Customer Product/Process Change Notification

PCN # OES17020101_593

P/N 593xxxxx0xxF will be discontinued and replaced by 593xxxxx3xxF. See attached Affected P/N List.

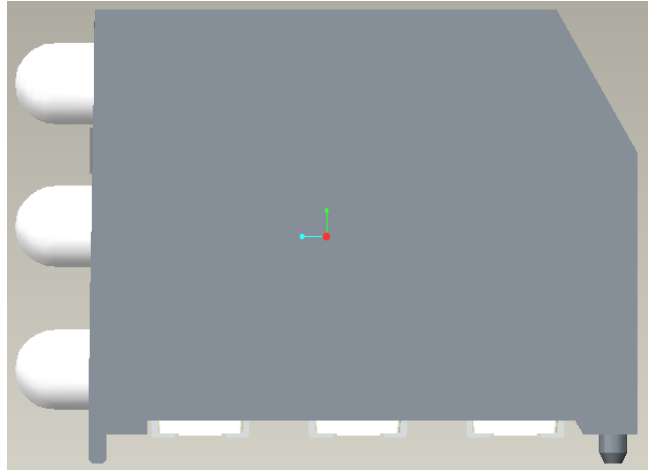
The Replacement P/N 593xxxxx3xxF is with a injection moldable Clear Silicone Lens with textured surface seated in two housing halves snapped together with one seating plane and improved LED coplanarity. The discontinued P/N 593xxxxx0xxF was with a hard transfer molded Hysol multiple lenses with a varied LED seating plane.

The silicone lens injection molds better with better mold yields and one lens reducing part count. The prior hard lens Transfer Molding Machine with long cycle an low yields will be Obsoleted. The new housing halves provide one seating plane for all three LEDs for better coplanarity.

Part Pad layout dimensions and seating plane remains the same for replacement parts.
